Historic Architectural Review Commission Staff Report for Item 8

Meeting Date: May 24, 2022

Address: #1209 Royal Street

Description of Work:

DRAWING TITLE:
 DEMOLITION PLANS & ELEVATIONS

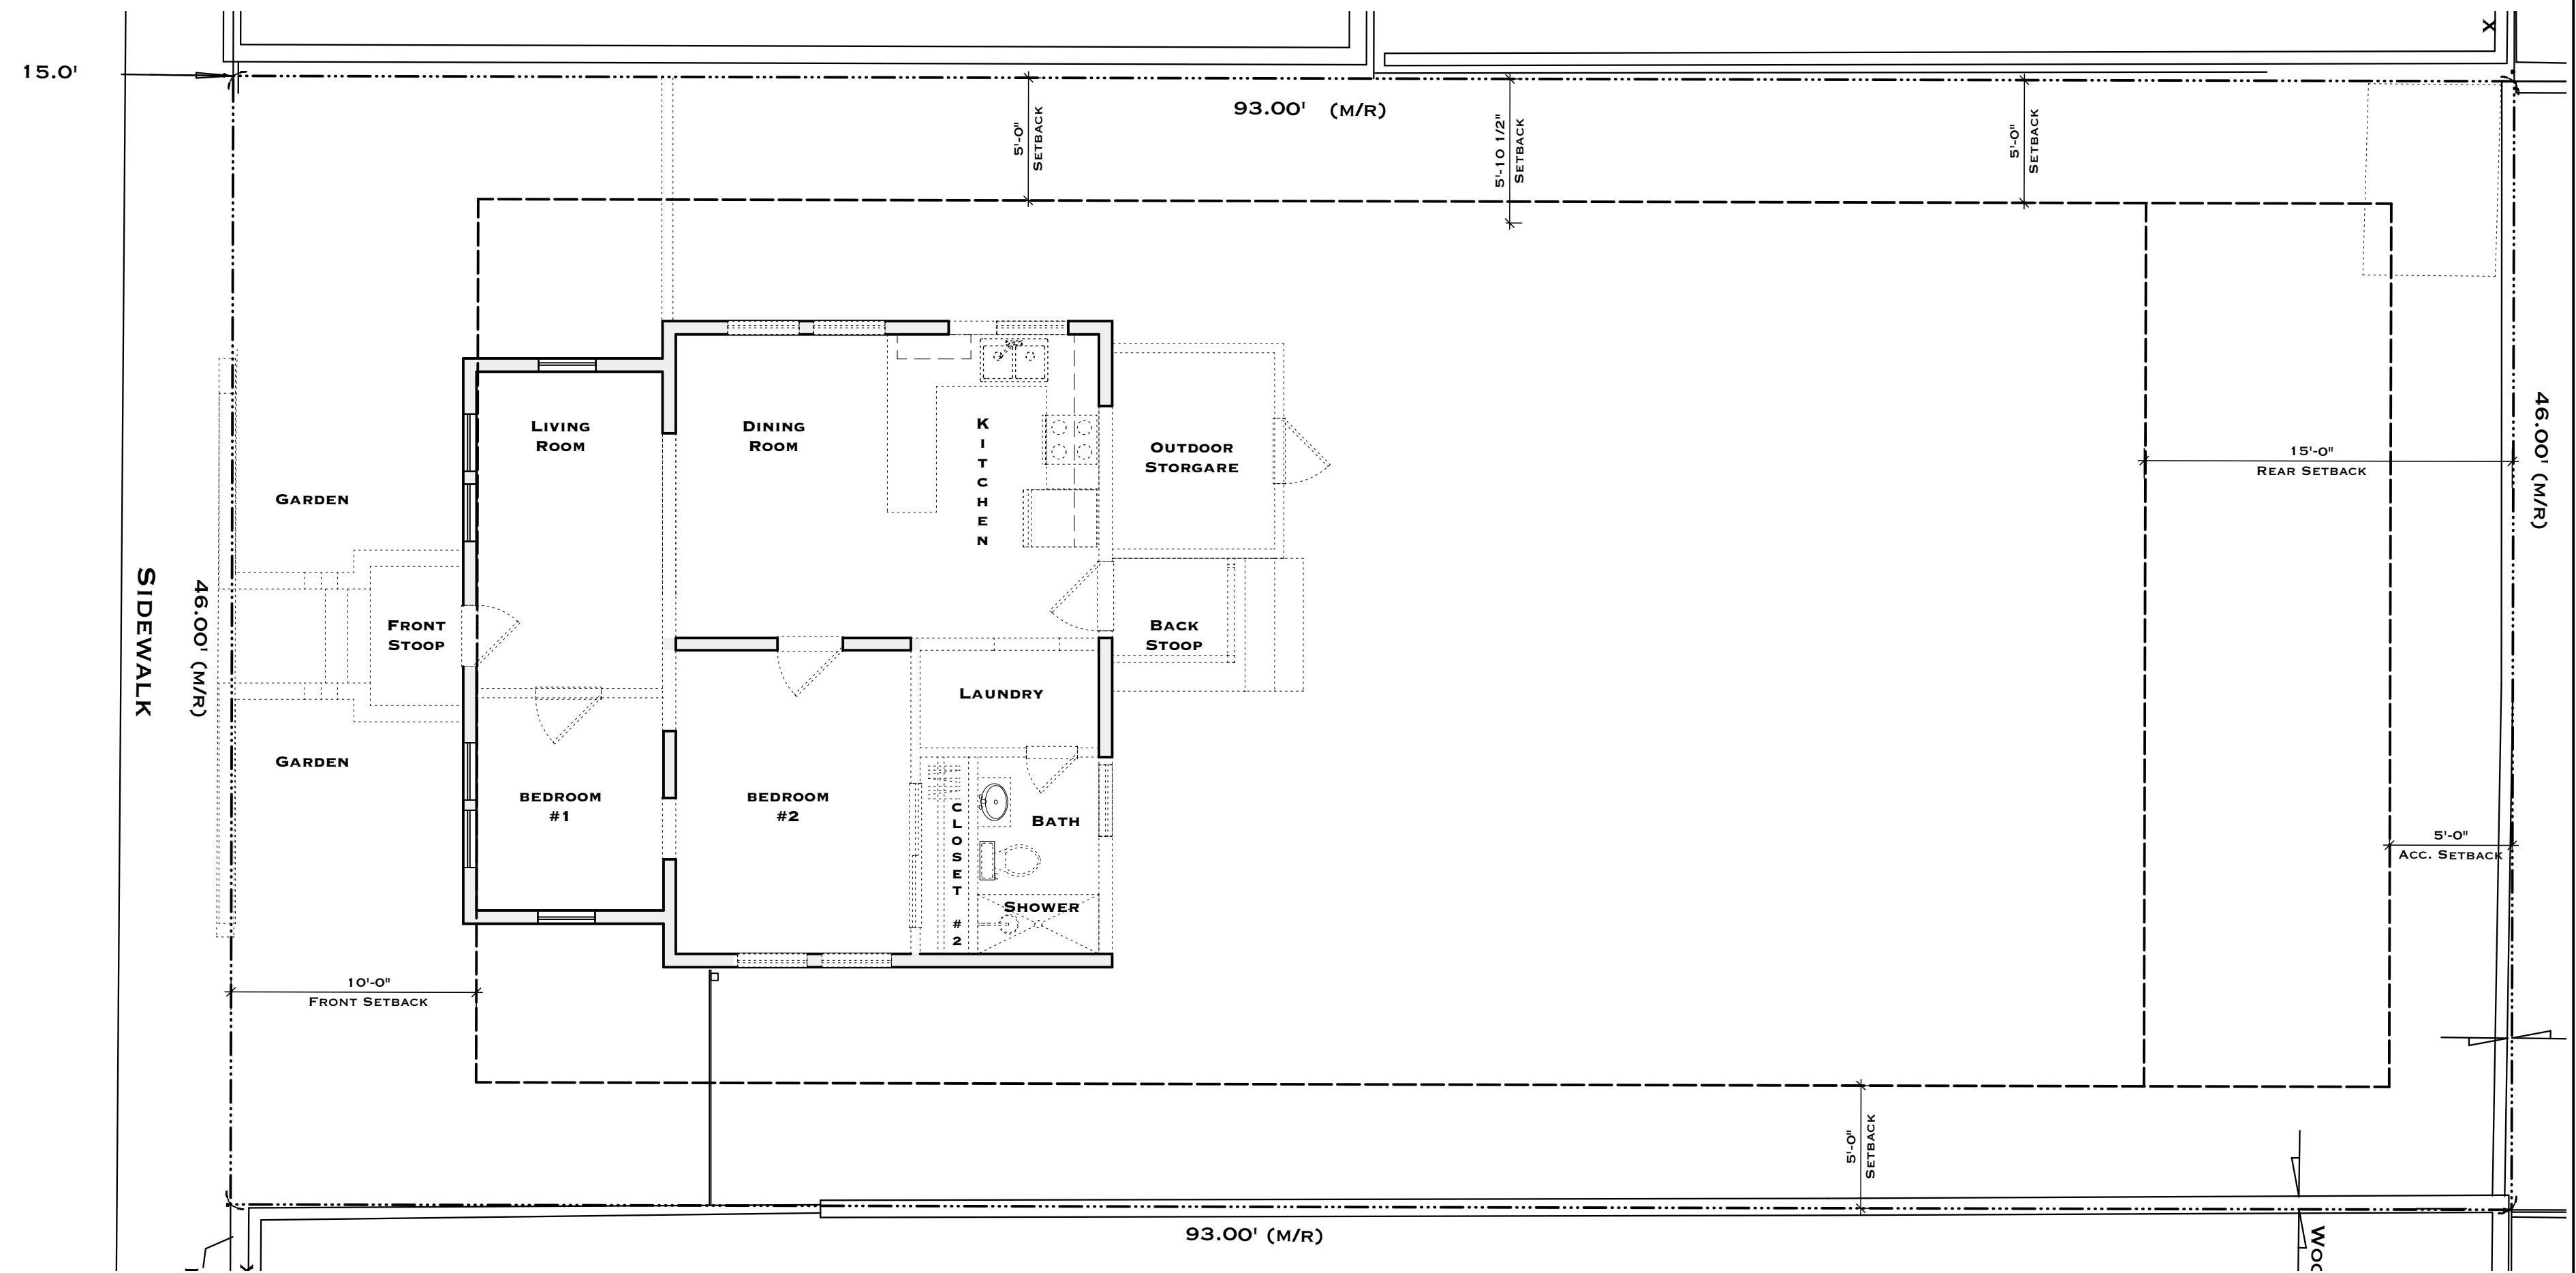
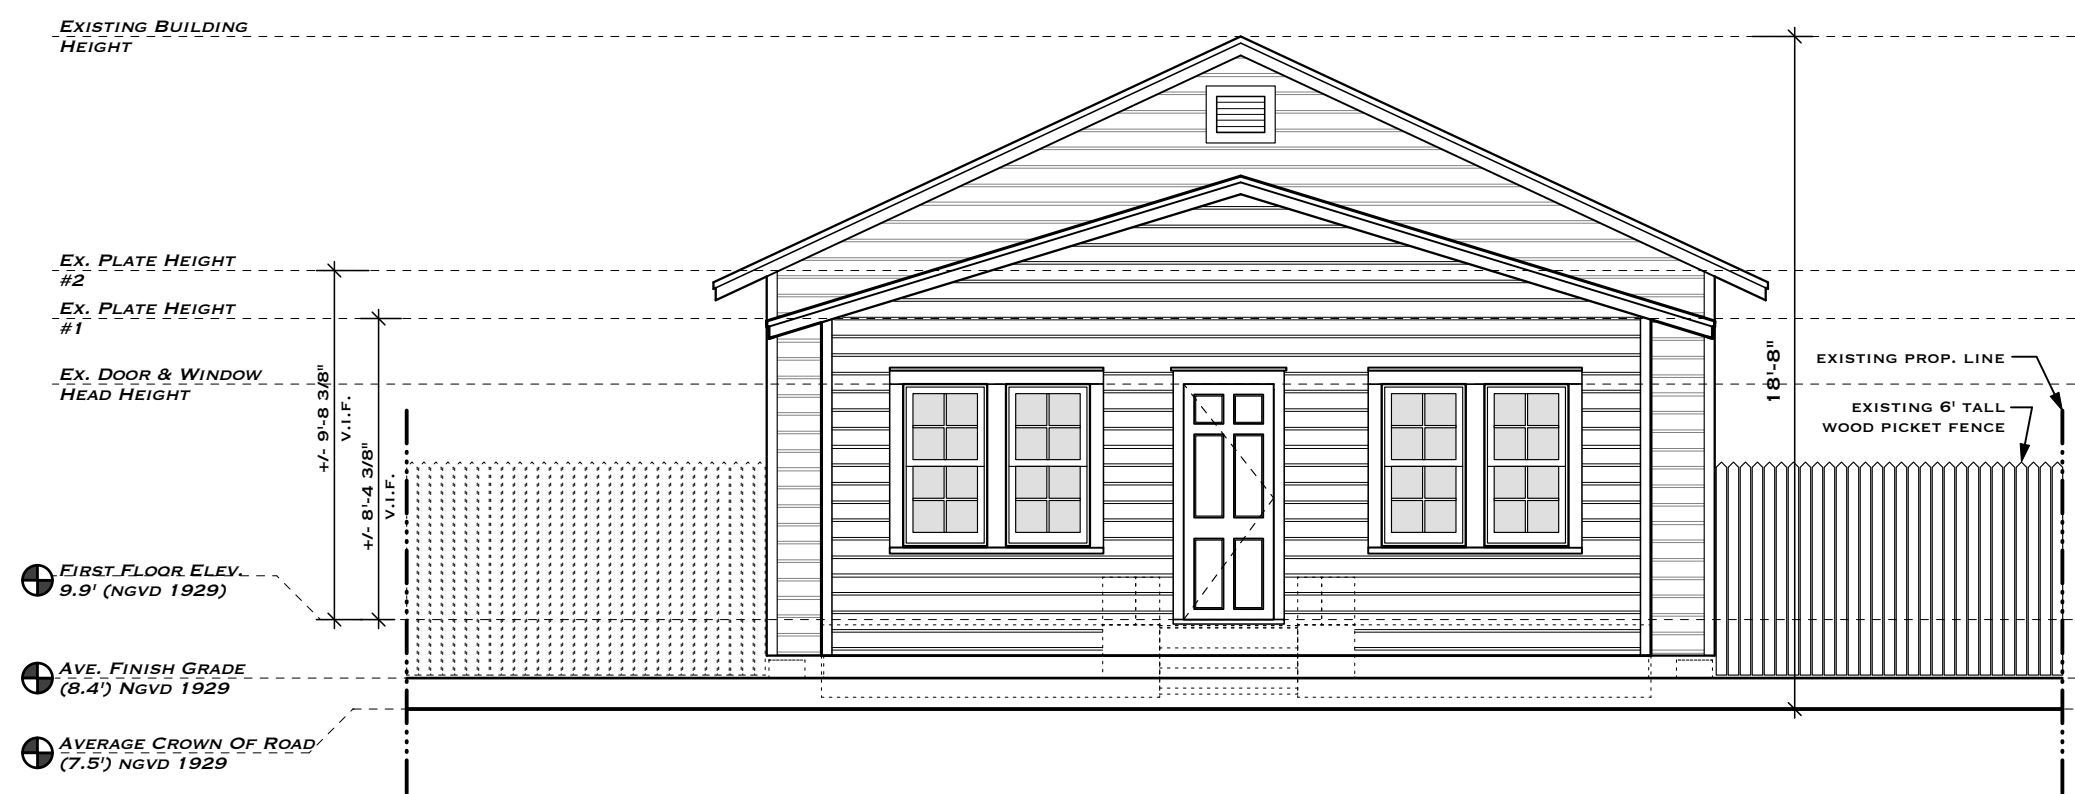
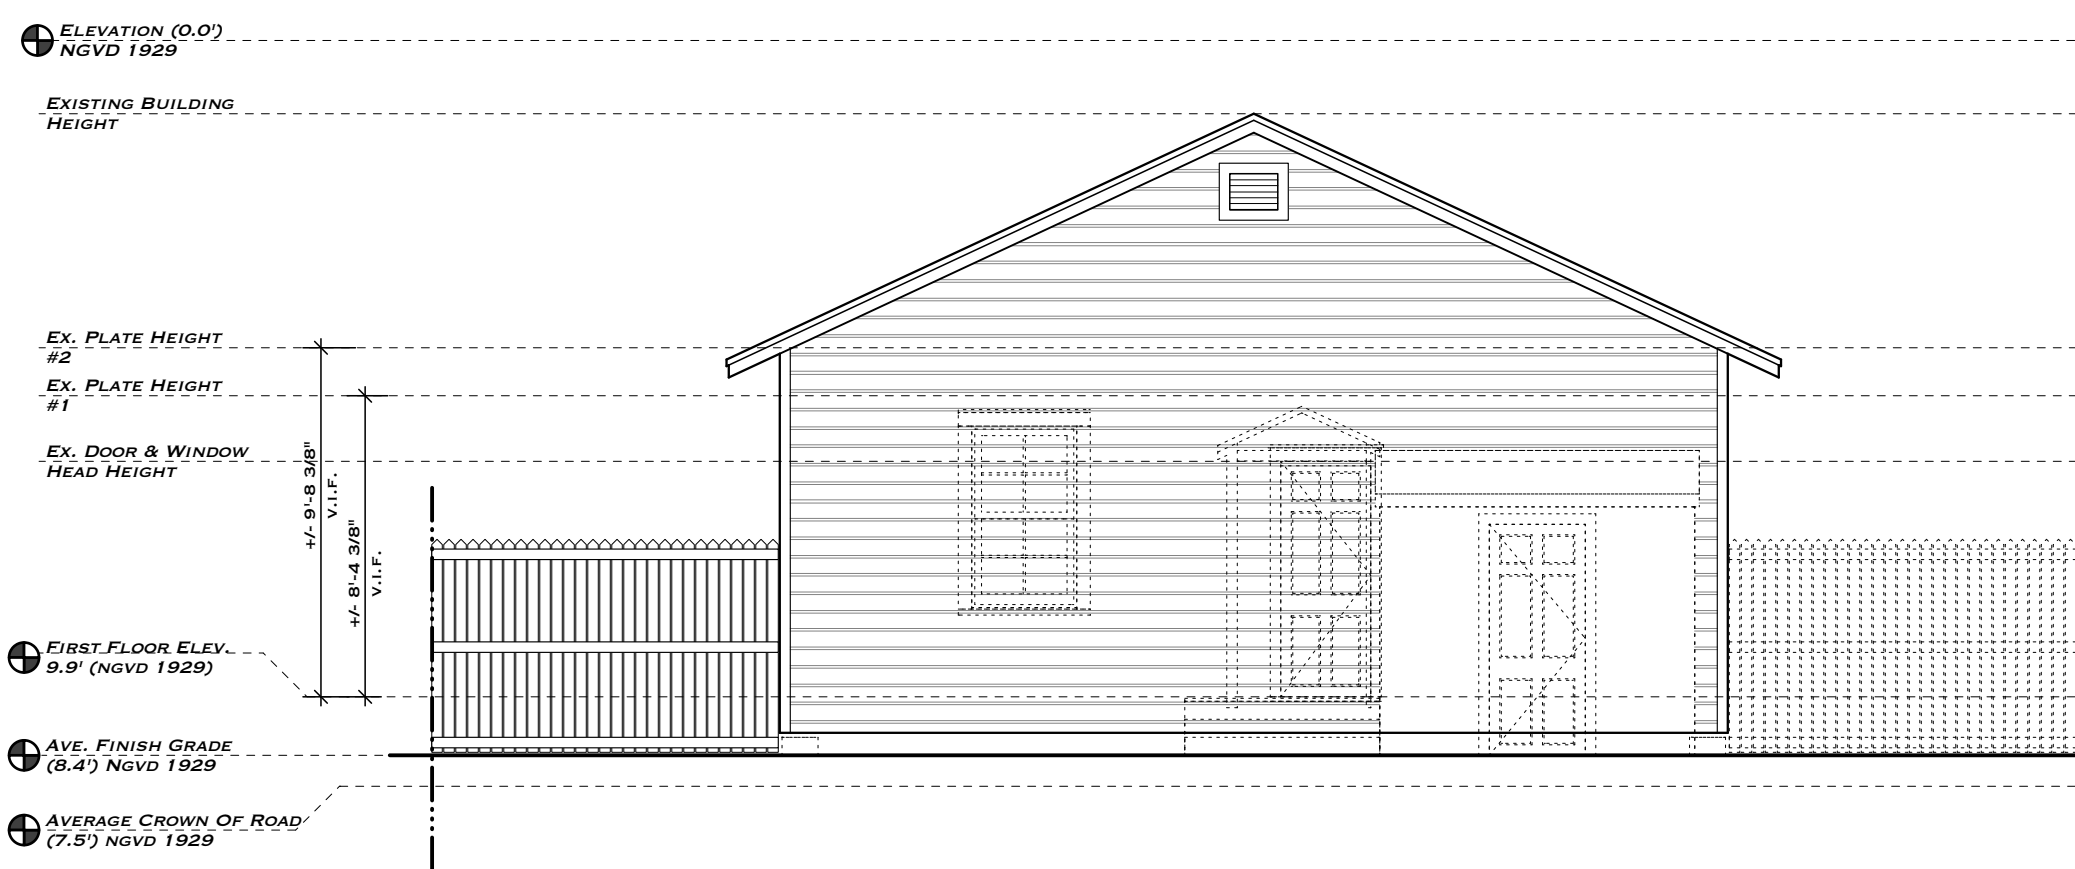
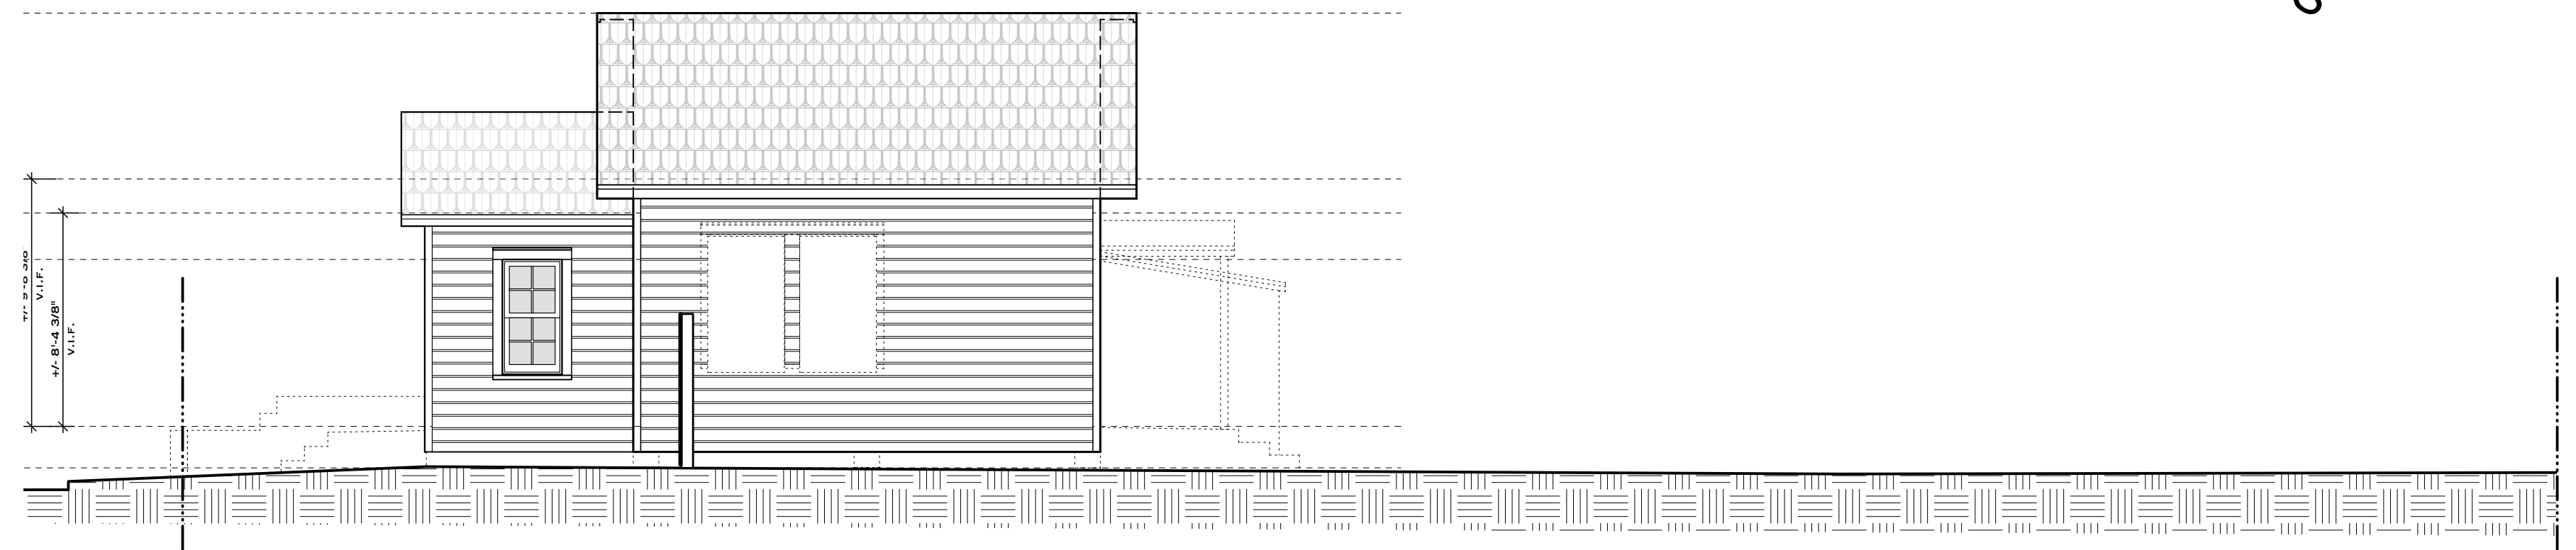
The Certificate of Appropriateness under review proposes the demolition of a shed addition at the rear of the house at 1209 Royal Street. The proposal also includes the removal of concrete stoops at the front and rear and low walls at the front and sides. Renovations and an addition to the historic house are under review as part of this application.

It is staff's opinion that the removal of the elements in question will not have a negative effect on the character of the surrounding neighborhood.

The elements in question are non-historic.

The elements under review for demolition have not acquired historic significance that is important to the site or surrounding district.

It is staff's opinion that the elements in question will not qualify as contributing elements to the site or to the historic district in the near future.
